Report: TAB Punchlist
Function: Test, Adjust, & Balance
Date: 01/06/2025
Completed By: National TAB

12-30-24 CAVA BRUNSWICK, NJ (MIDSTATE MALL)

Issue List

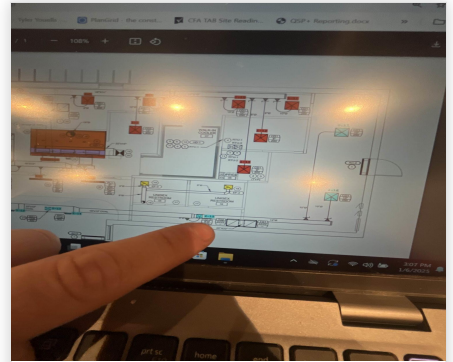
Issue Name : Dining-BOH Transfer Grille
Description : Transfer grille is not connected from dining corridor to the BOH storage room. Duct connection at the one grille is not well sealed.
Created By : National TAB **Assigned To :** National TAB - Tyler Youells
Status : Open
Priority : Low **Asset Tag :**
Originated Date : 01/06/2025 - Tyler Youells - National TAB

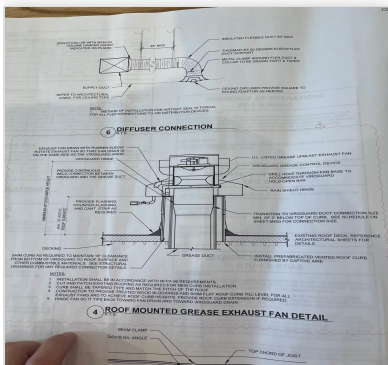
Issue Name : KEF-1 Grease cup
Description : KEF-1 Grease cup is not yet installed. Grease will drip onto roof when cooking starts
Created By : National TAB **Assigned To :** National TAB - Tyler Youells
Status : Open
Priority : Low **Asset Tag :**
Originated Date : 01/06/2025 - Tyler Youells - National TAB

- **01/06/2025 National TAB - Tyler Youells**
 - PER Revision KEF-1 is supposed to have a Viroguard Grease trough installed and not a grease cup.

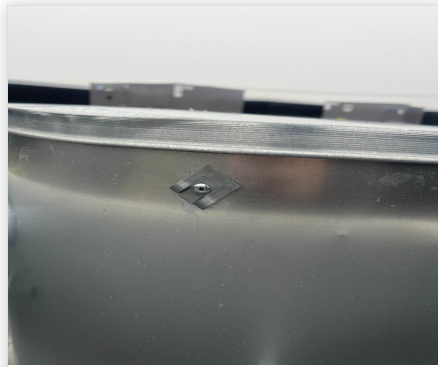
Issue Name : KEF-1 Lid latches
Description : The kid on KEF-1 is missing two of the three latches.
Created By : National TAB **Assigned To :** National TAB - Tyler Youells
Status : Open
Priority : Low **Asset Tag :**
Originated Date : 01/06/2025 - Tyler Youells - National TAB

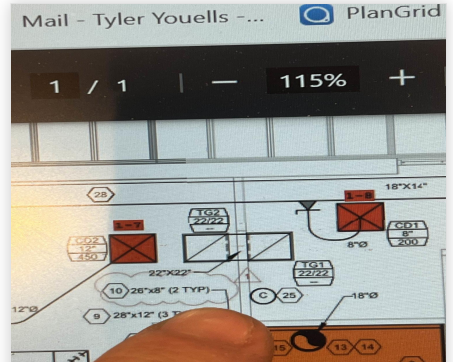
Issue Name : Kitchen Transfer Grille
Description : Kitchen Transfer grille is not connected to the BOH side. Kitchen side is also not sealed to the grille.
Created By : National TAB **Assigned To :** National TAB - Tyler Youells
Status : Open
Priority : Low **Asset Tag :**
Originated Date : 01/06/2025 - Tyler Youells - National TAB
